工程指示 / 要求簡箋(E.I.)

工程指示編號：EI / 1515 / 20 修改版次：

工程名稱：亞皆老街中電

工程項目：Showflat 後加工程

Rev 修订	Date 日期	Note 备注	Rev 修订	Date 日期	Note 备注	Project 工程名称	Title 项目	Drawing No. 图号
A						CLP	W1103-P W103-Uuit A ENSULTE	007
B					ARCHITECTURAL ACOUSTICS		Job No. 工程编号 -	Date 日期 2019-10-16
C					建筑声学		Drawn 绘图 QING	Scale 比例 A3
D							Check 校核 Austin	Rev 修订 A

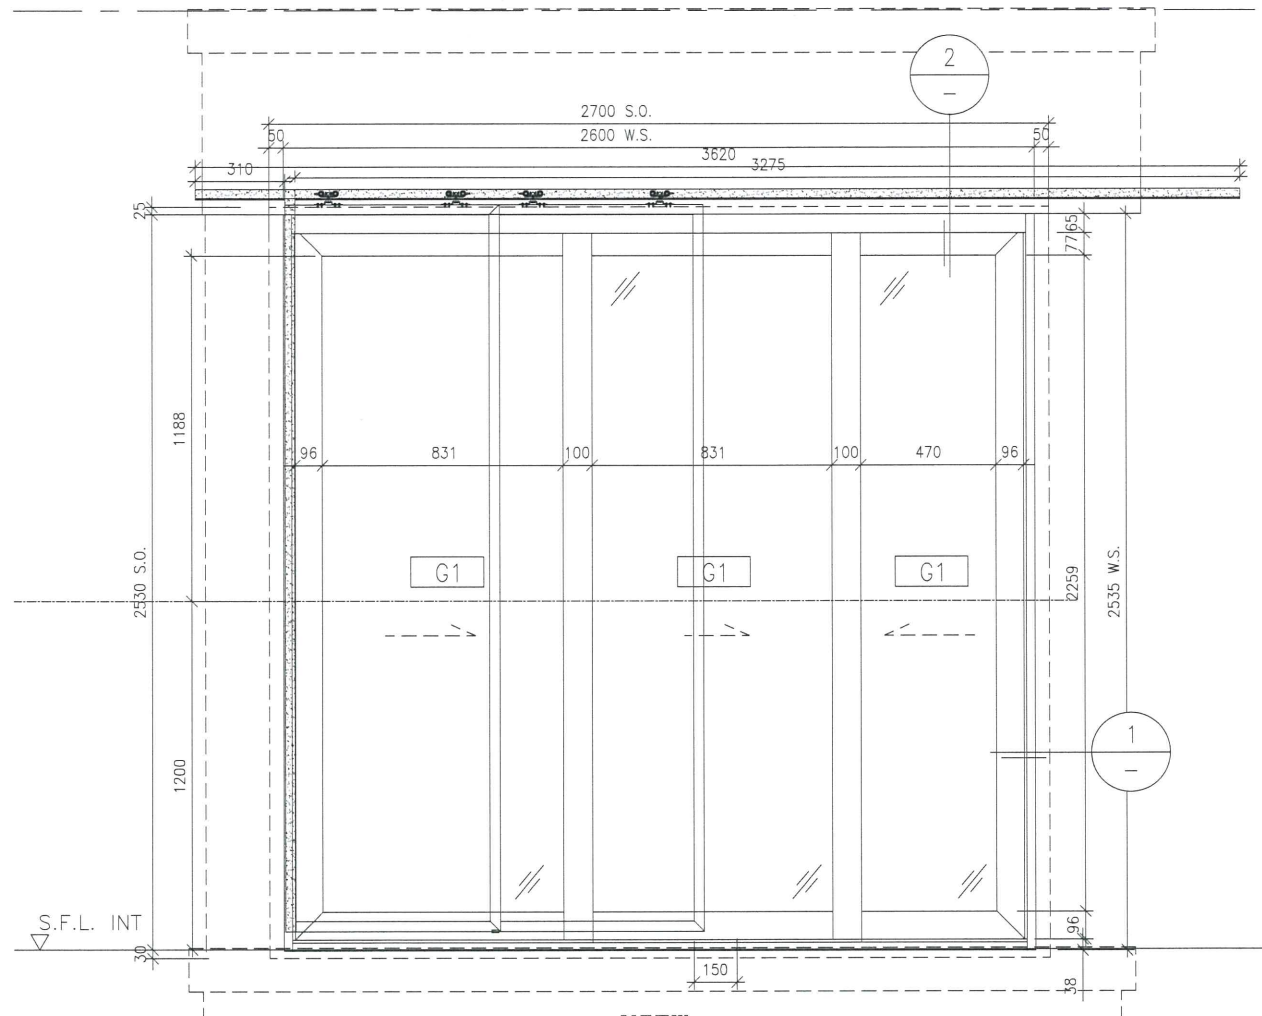
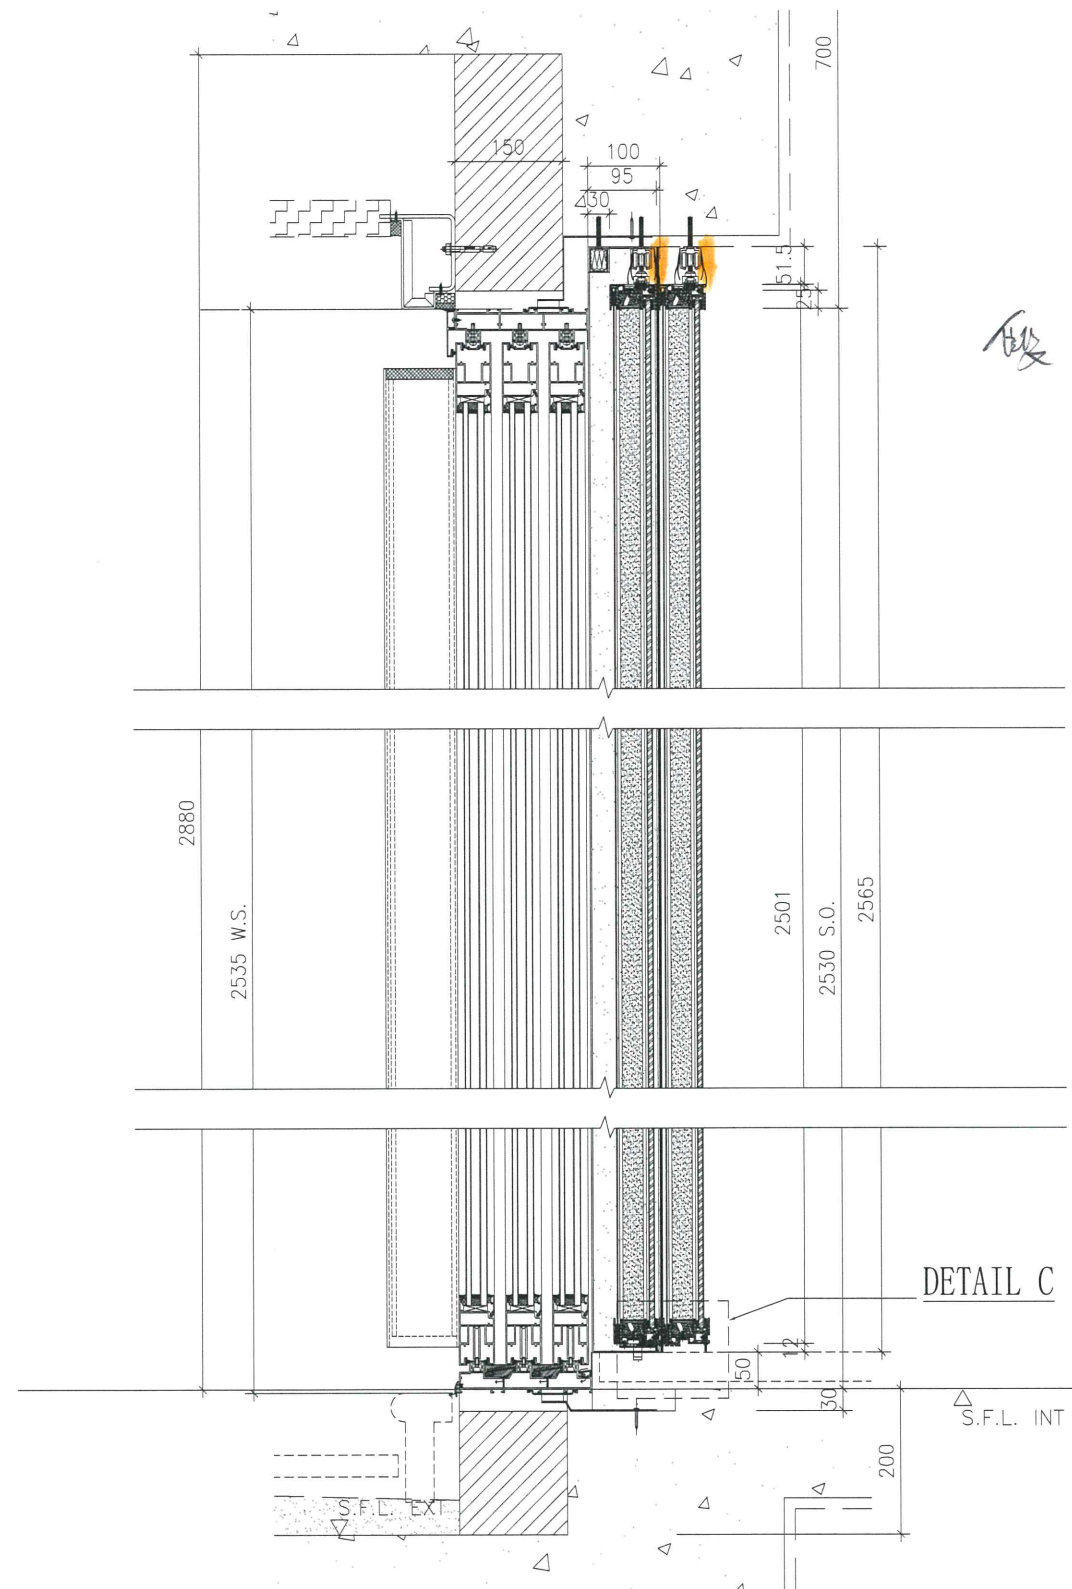
鉛板長度 = 3300 mm (覆尺數)

做路軌

加鉛板位置

Rev 修订	Date 日期	Note 备注	Rev 修订	Date 日期	Note 备注	Project 工程名称	Title 项目	Drawing No. 图号
A						CLP	W1120-P W106-Unit C LIV.	001B
B					ARCHITECTURAL ACOUSTICS		Job No. 工程编号 -	Date 日期 2019-10-25
C					建筑声学		Drawn 绘图 QING	Scale 比例 A3
D							Check 校核 Austin	Rev 修订 B

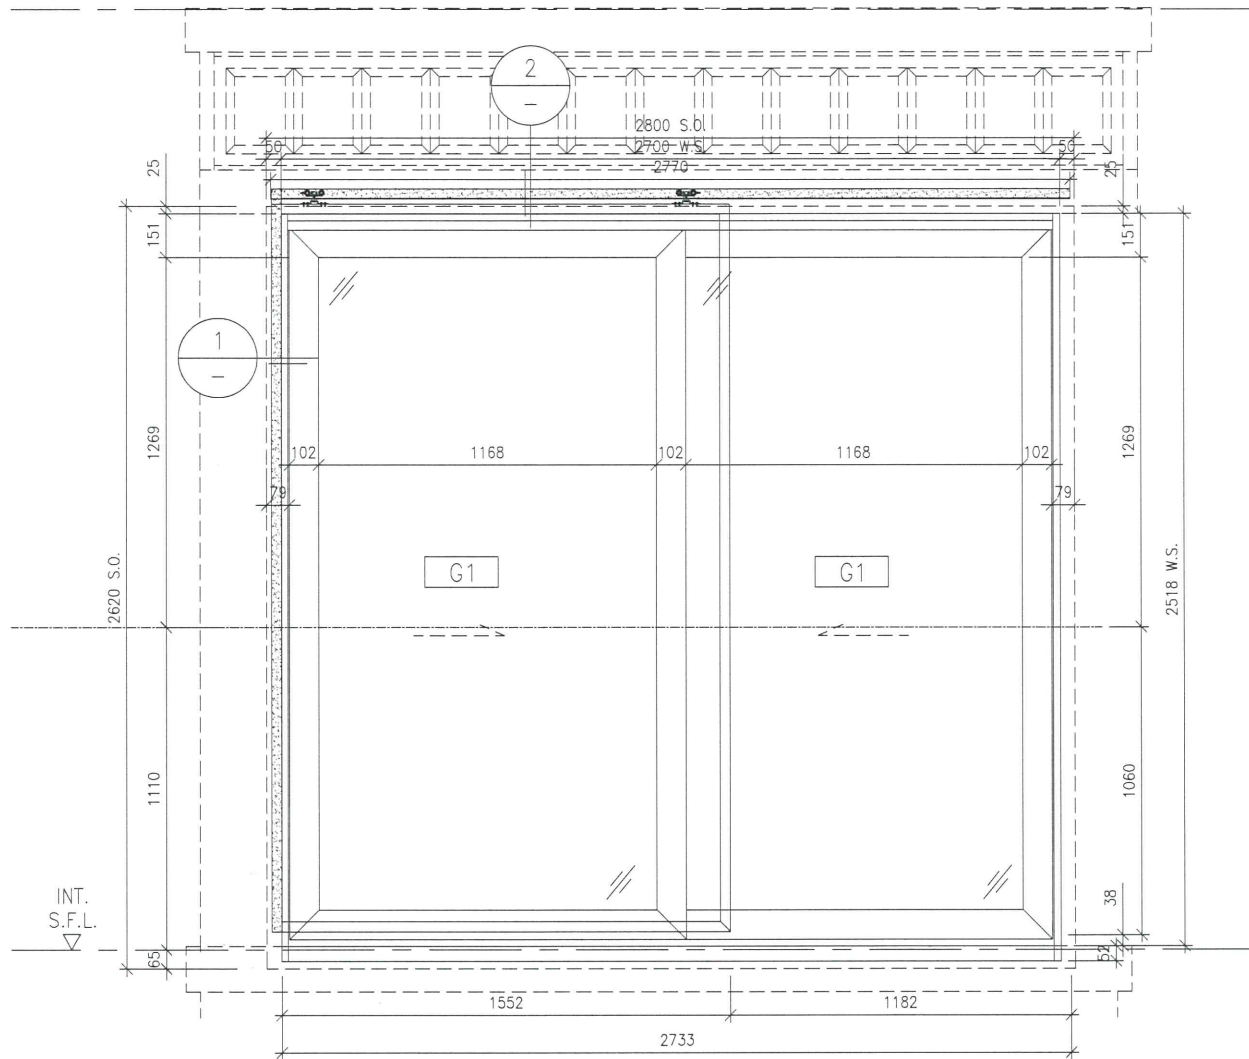
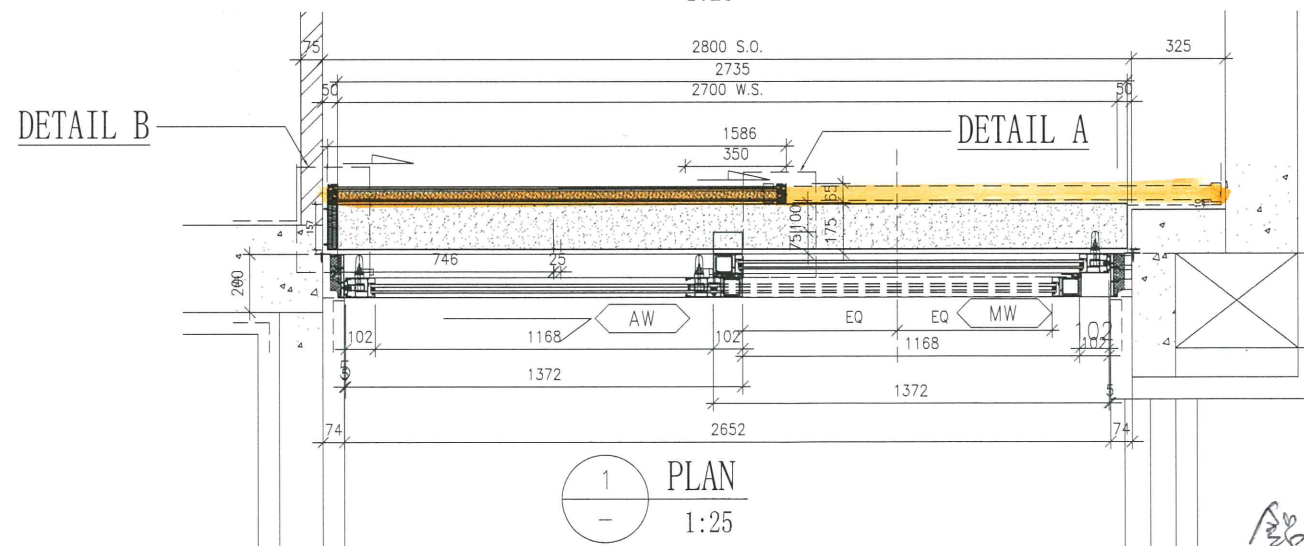
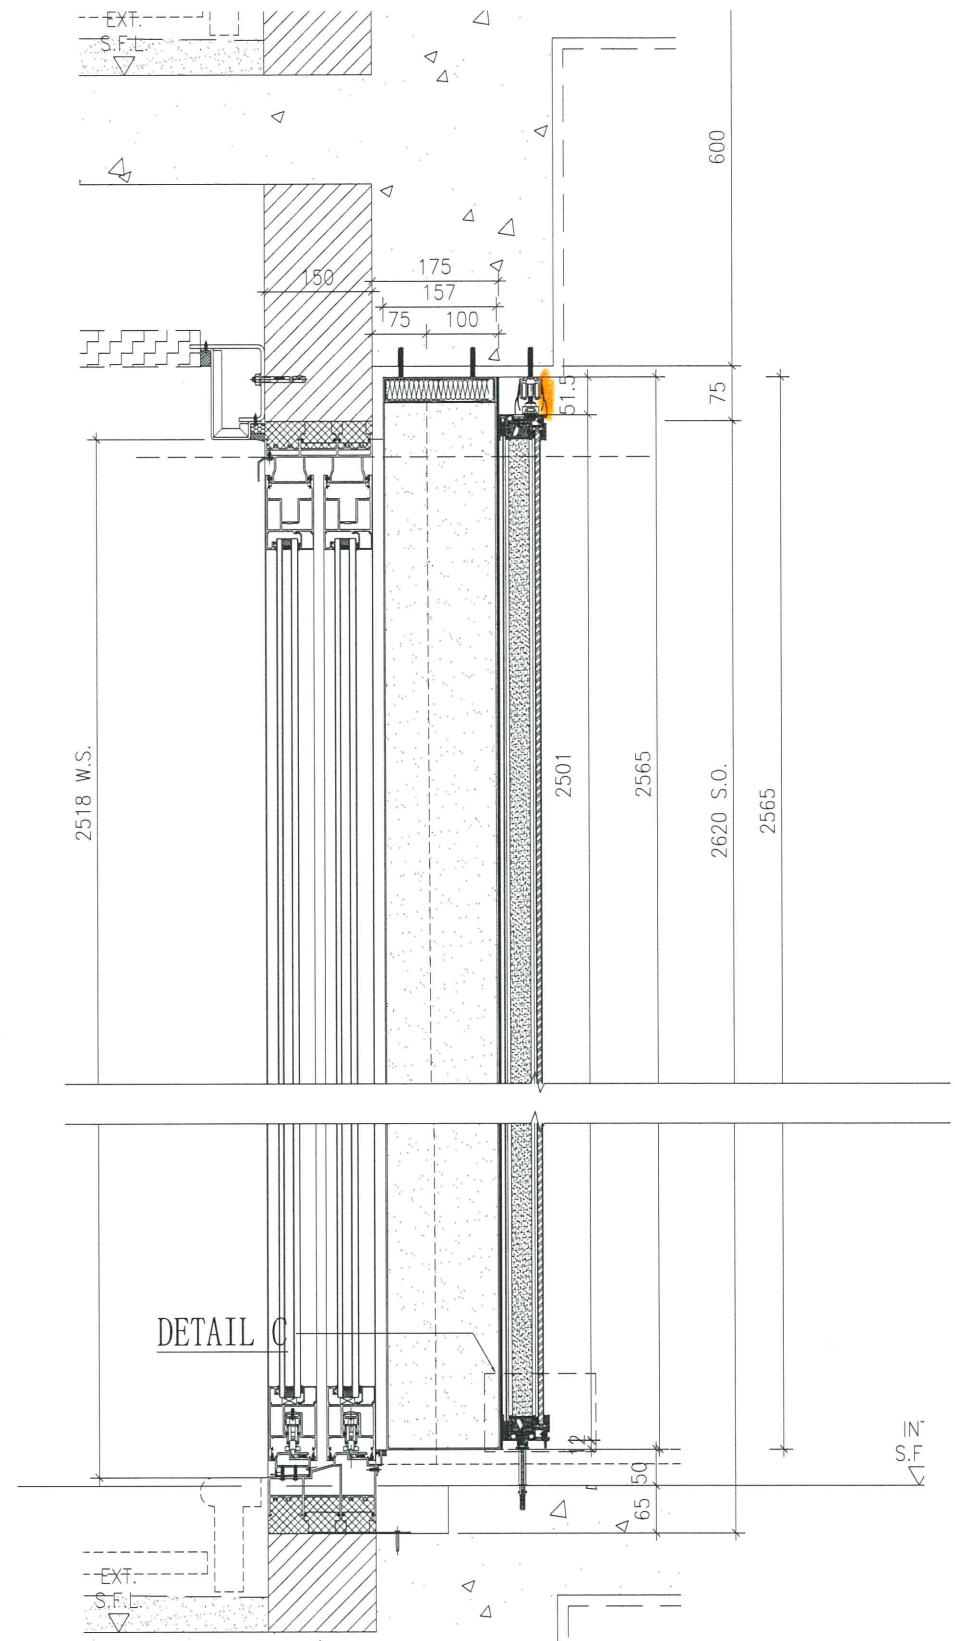
鋁板厚度=3300mm
(表尺數)

加鋁板位置

Additional Alum. Capping for snowflant
(Flat A Balcony)

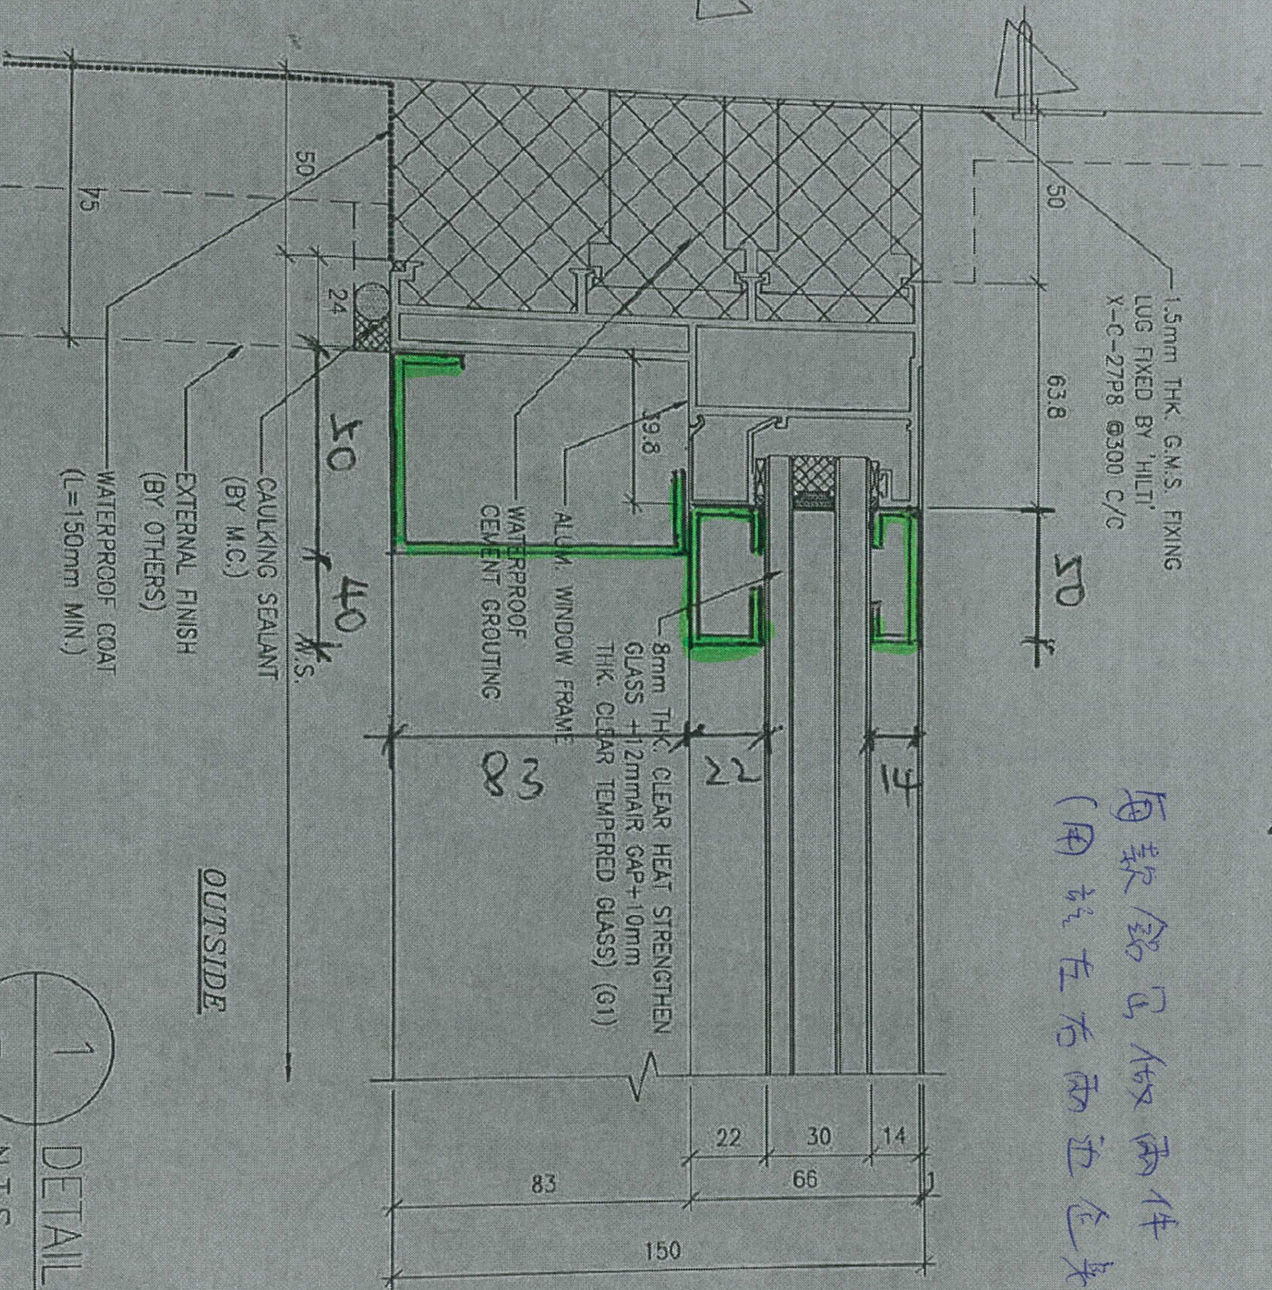
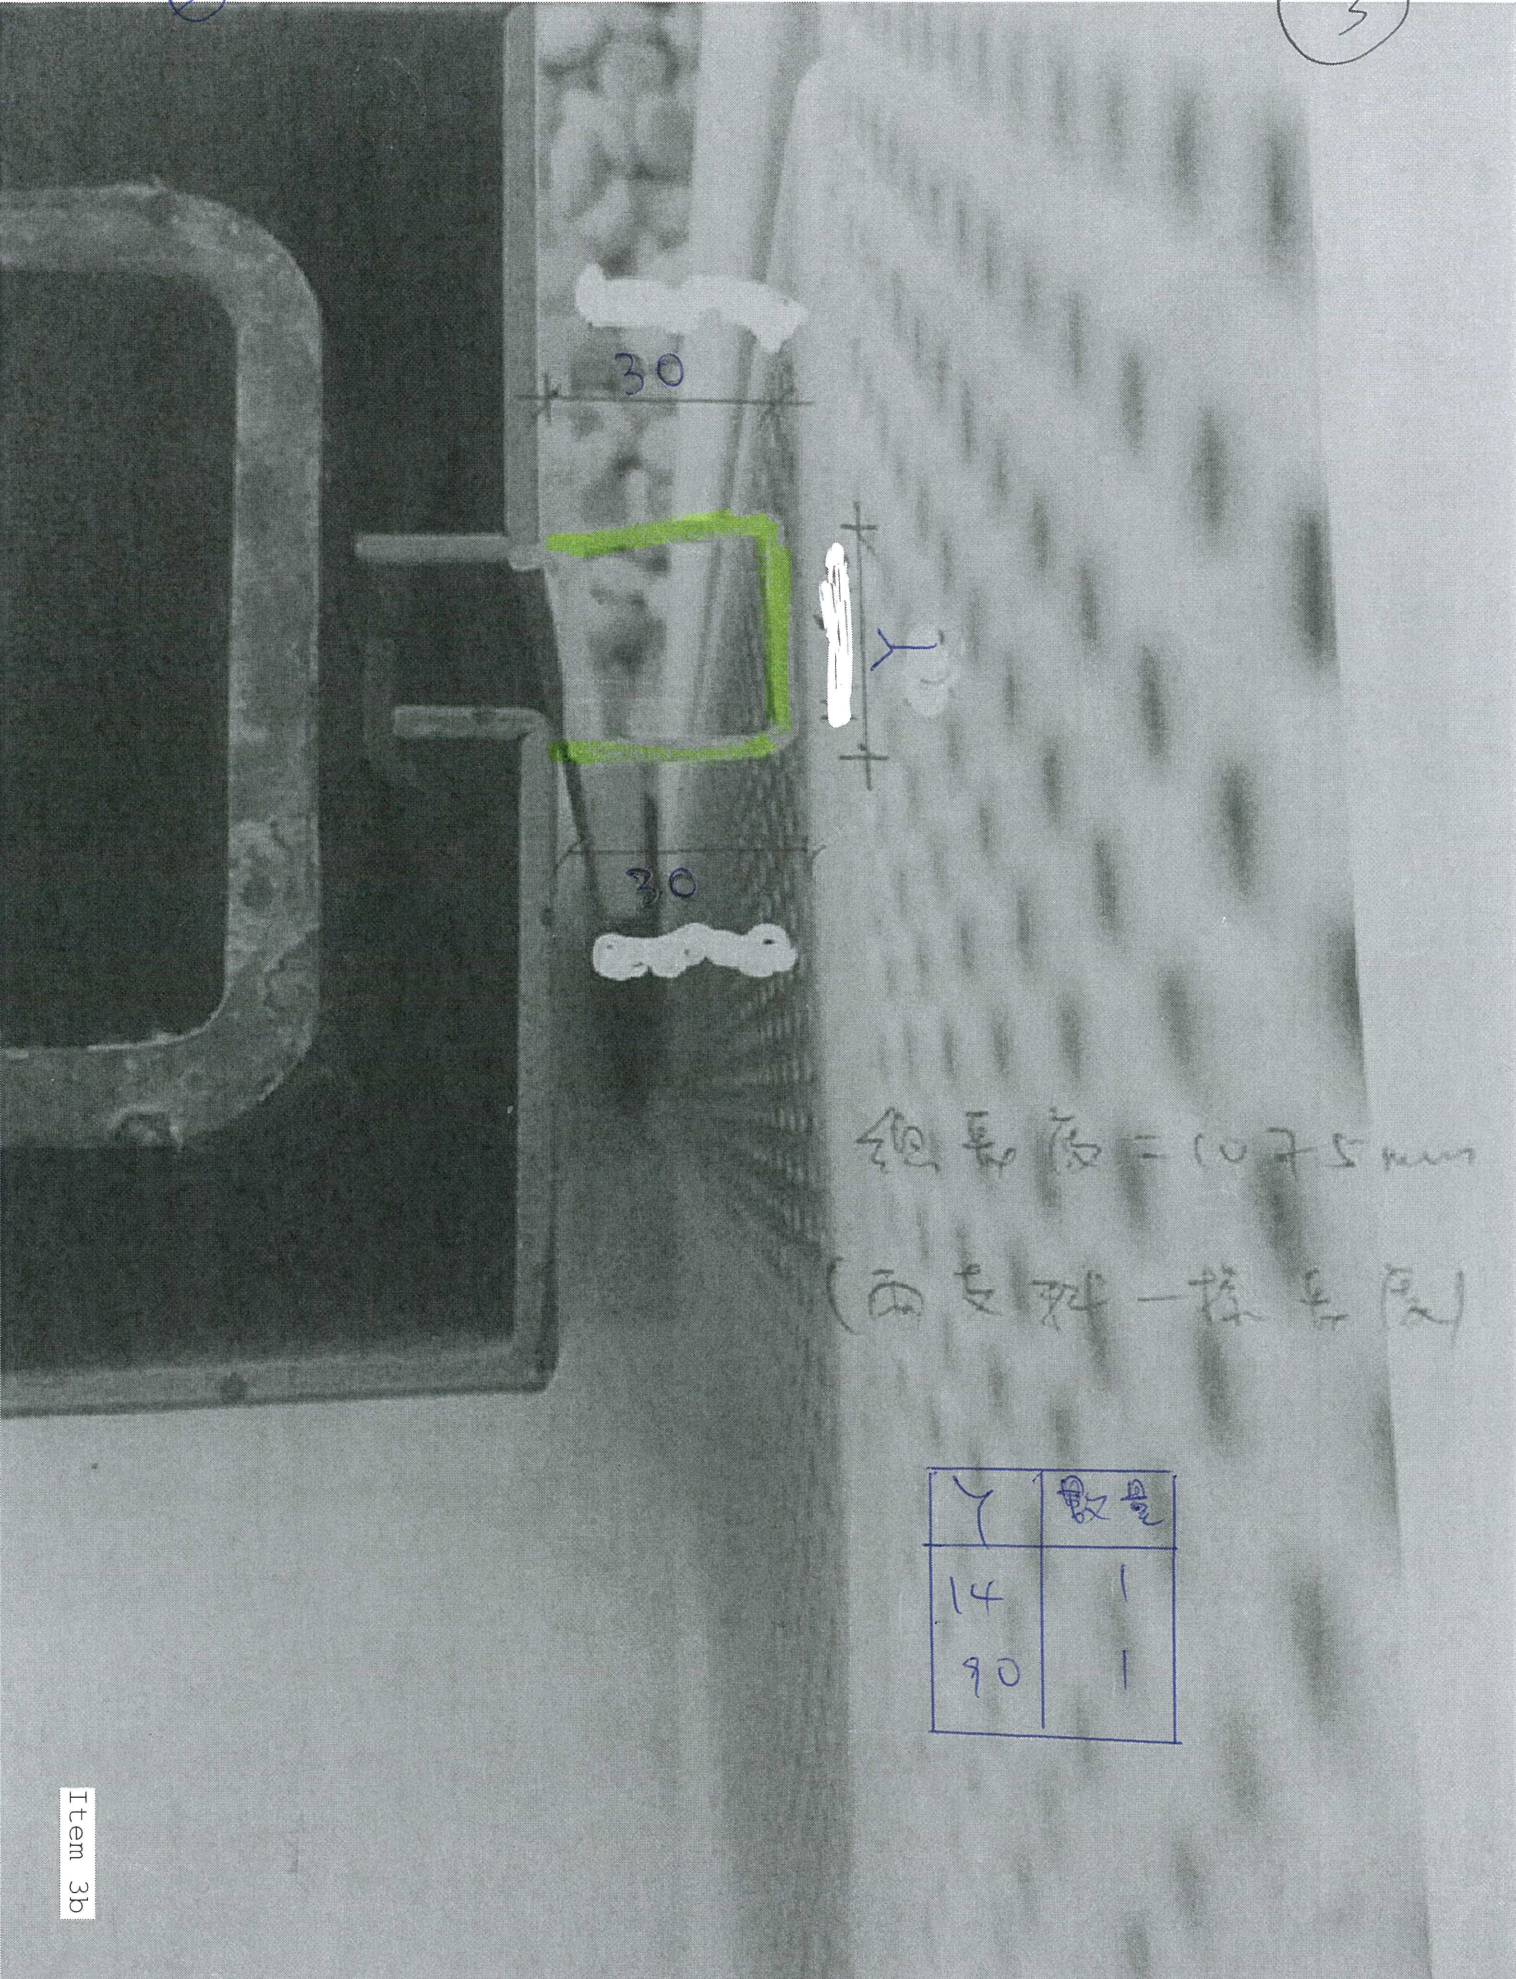
2. Flat A 大露台 左右兩邊企身加鋁匣 (室內加室外)

每款铝窗做两件
(用放在右两边包身)

總寬度 = 1075 mm
 (兩邊料 - 樣毛度)

總長度 = 107.5 mm
 (兩支料一樣長度)

CL-03

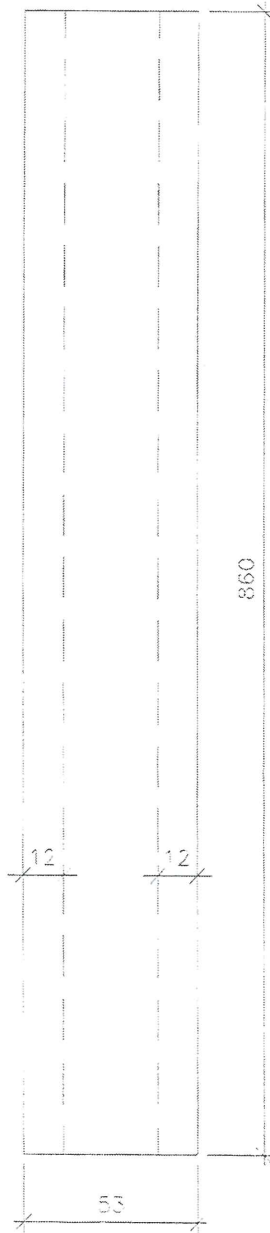
新原原有之鋁花
高度是55mm

請看CL-03

1mm 鋸板
